FOI reference: 21-123

**RE: FOI REQUEST COMMUNITY FEEDBACK SOUTHERN MEMORIAL PARK DEVELOPMENT**

**Southern Memorial Park  
draft masterplan**

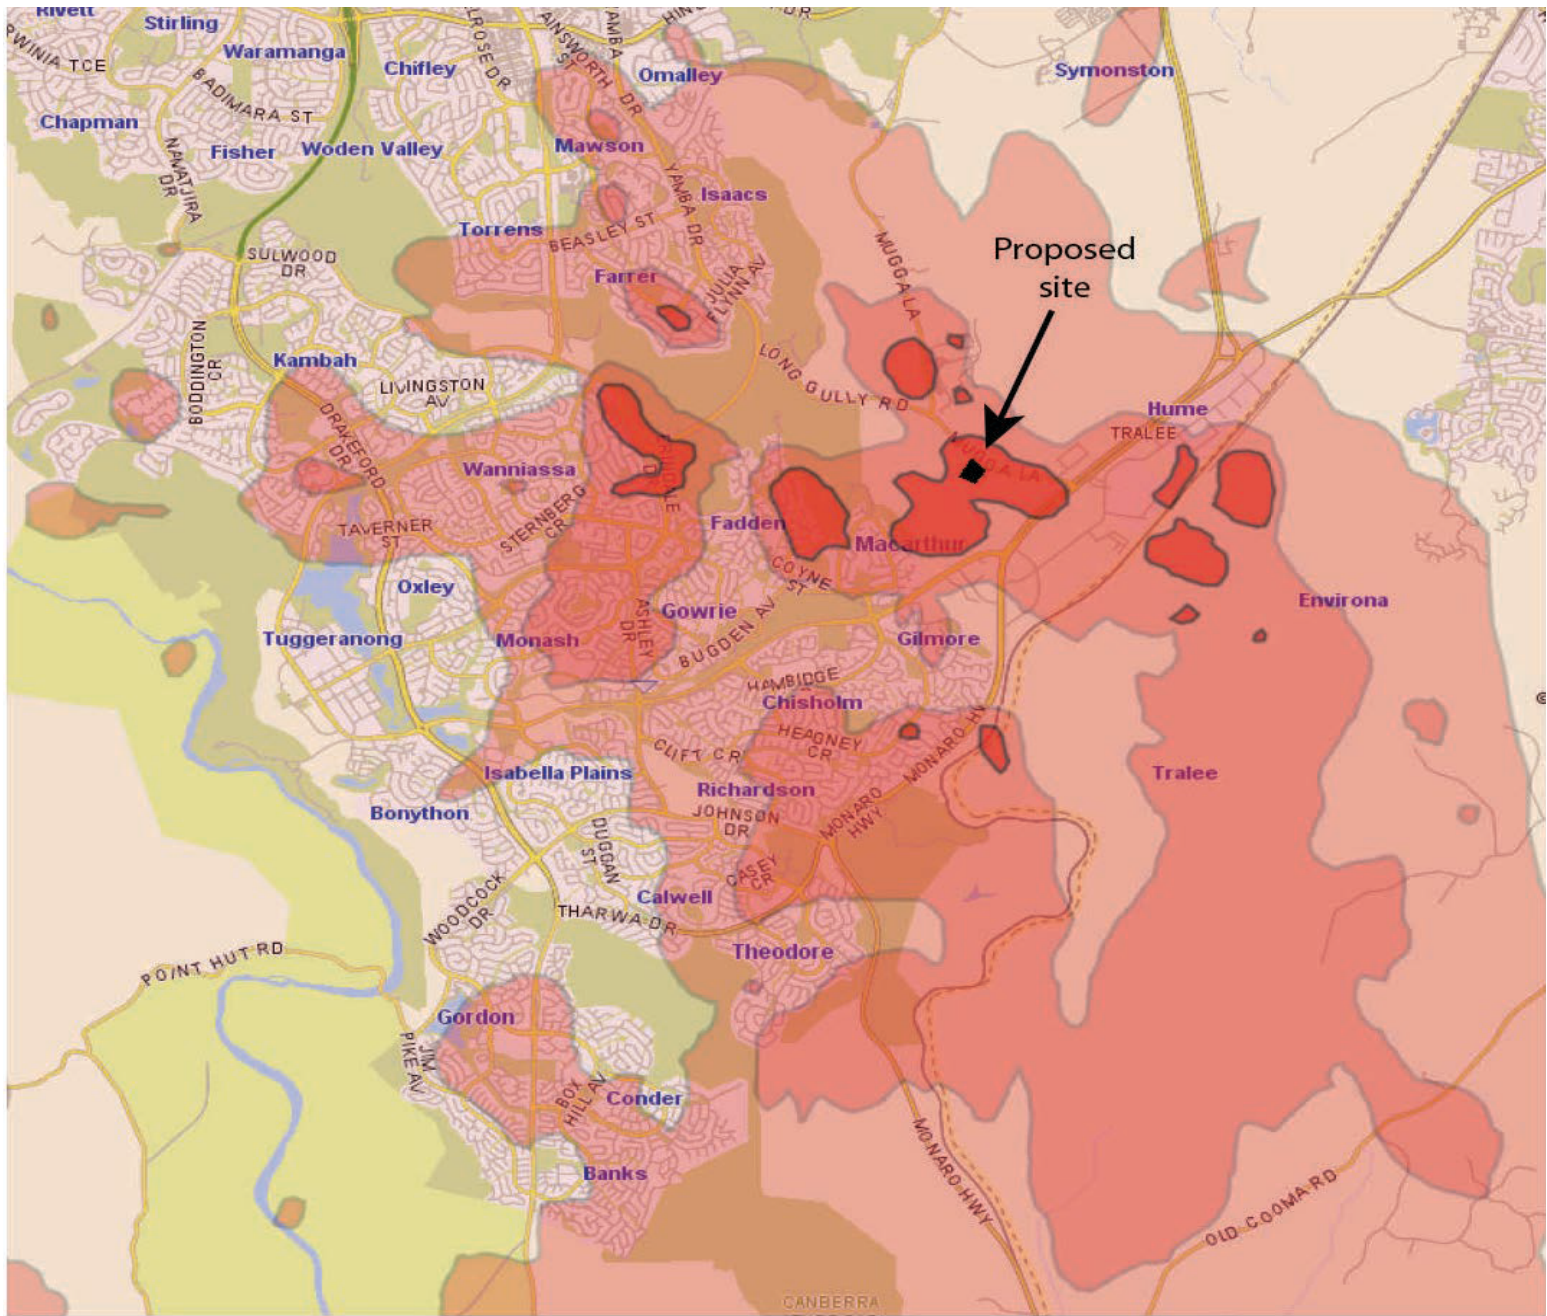
The Pacific Air & Environment CALPUFF study for the gas-fired power station identified pollution “hotspots” in Fadden, upper Wanniasa, upper Farrer, Macarthur, Hume-Tralee and Chisholm [15] (Figure 1). The pollution-concentrating effects of the pronounced ridge-and-valley topography of the upper Jerrabomberra, Tuggeranong and Woden valleys makes the upper Jerrabomberra Valley a particularly poor choice for siting a crematorium and probably one of the worst possible locations in the ACT.

Figure 3 Shrinking Southern Wildlife Corridor. Notice the narrowness of the corridor between the Southern Memorial Park and Macarthur.

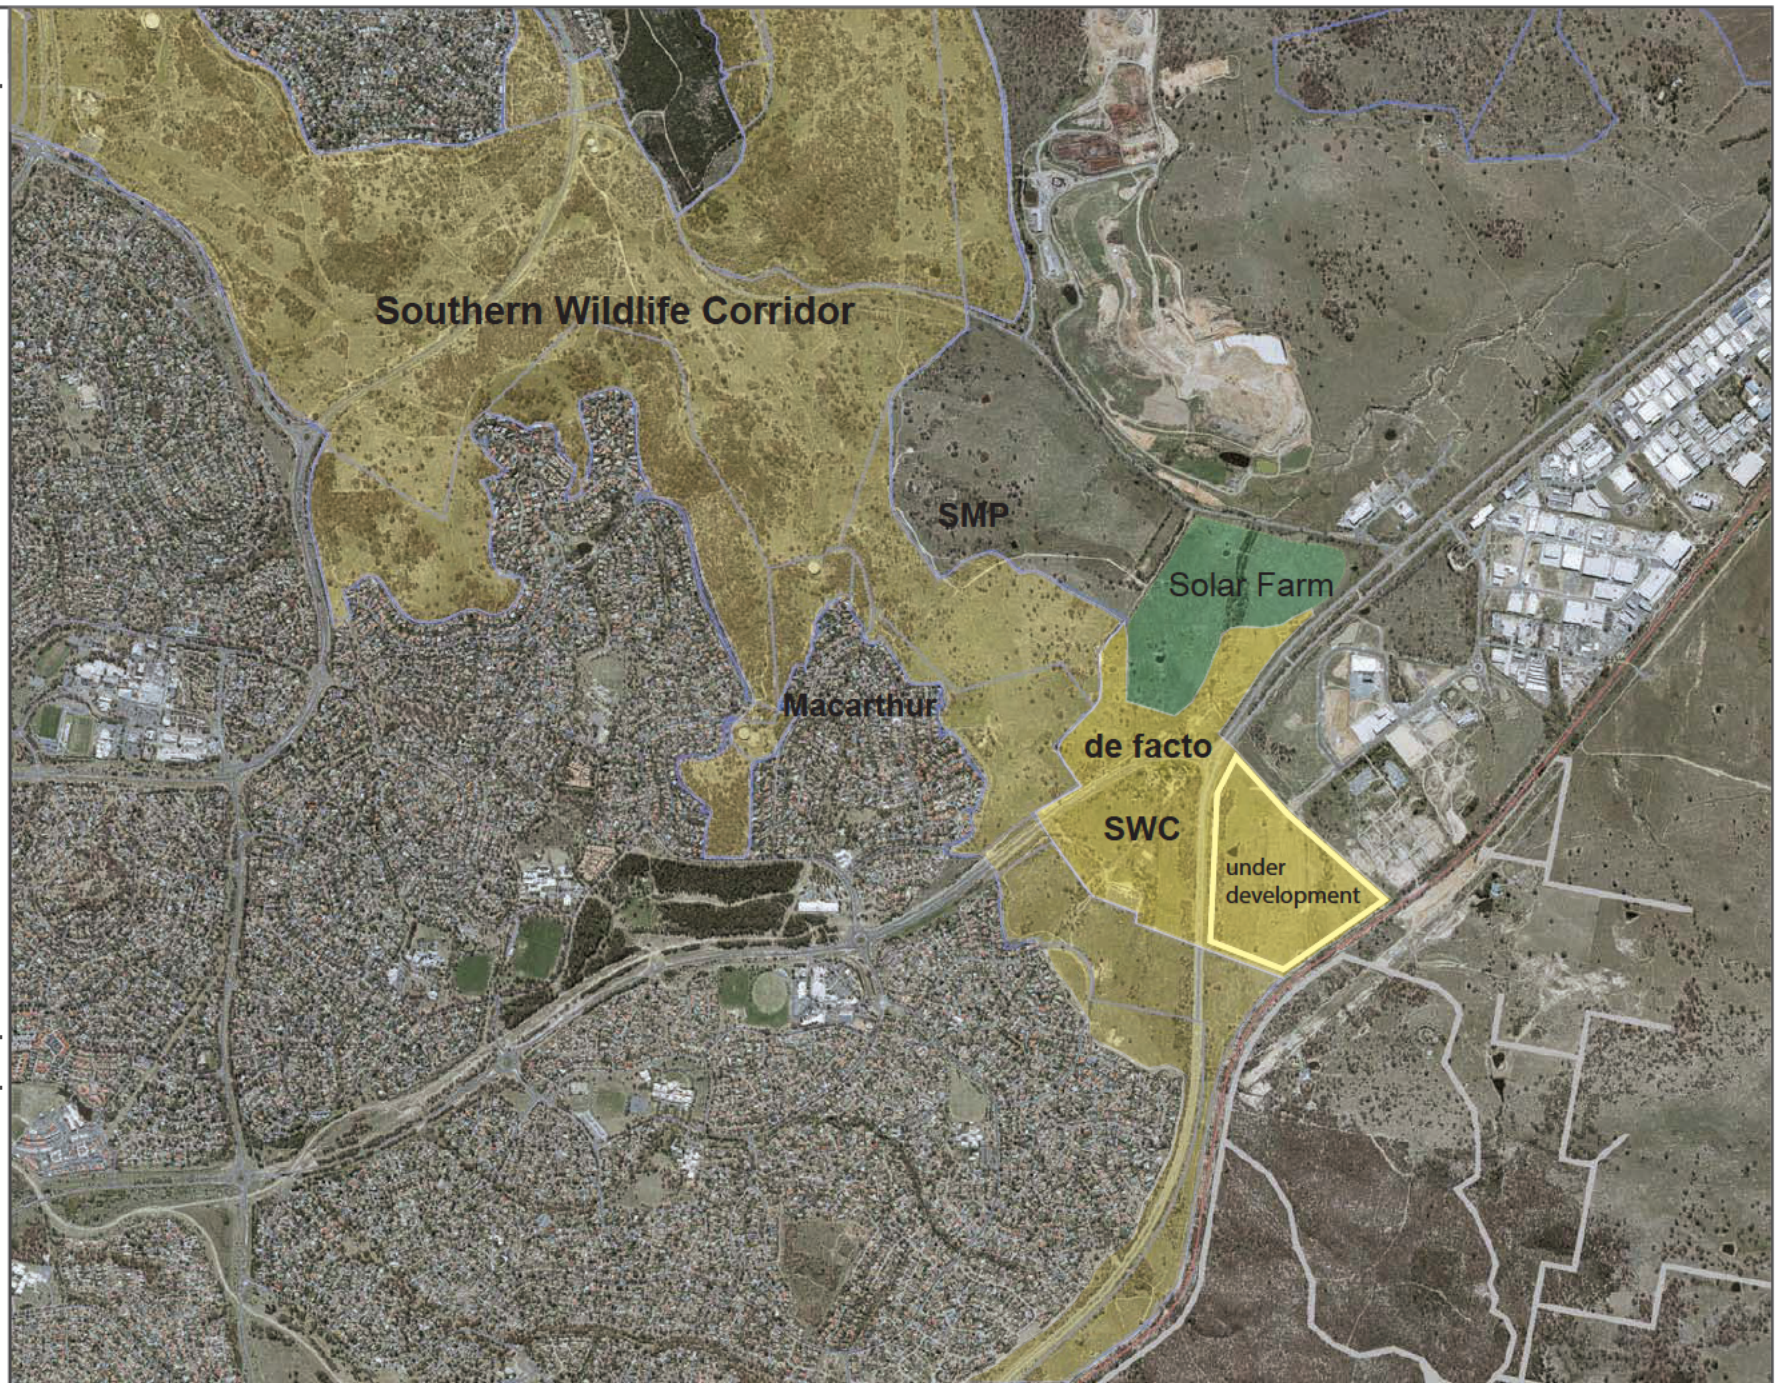
Development of the Southern Memorial Park will further intrude on the Southern Wildlife Corridor whose functionality is already limited by the Mugga Lane solar farm and southward extension of the Hume industrial complex. Open western and southwestern boundaries of the Southern Memorial Park so as to allow unimpeded wildlife access are a must to preserve the Southern Wildlife Corridor as a functional unit.

Provision of wildlife overpasses and/or underpasses across Isabella Drive and the Monaro Highway are sorely needed to preserve access to, and exchange with, the NSW wildlife corridor across Pemberton Hill, southeast of the Southern Memorial Park and south of the Tralee and Environa Homesteads (Figure 3). Over/underpasses should be constructed as part of the forthcoming realignment of the Monaro Highway.
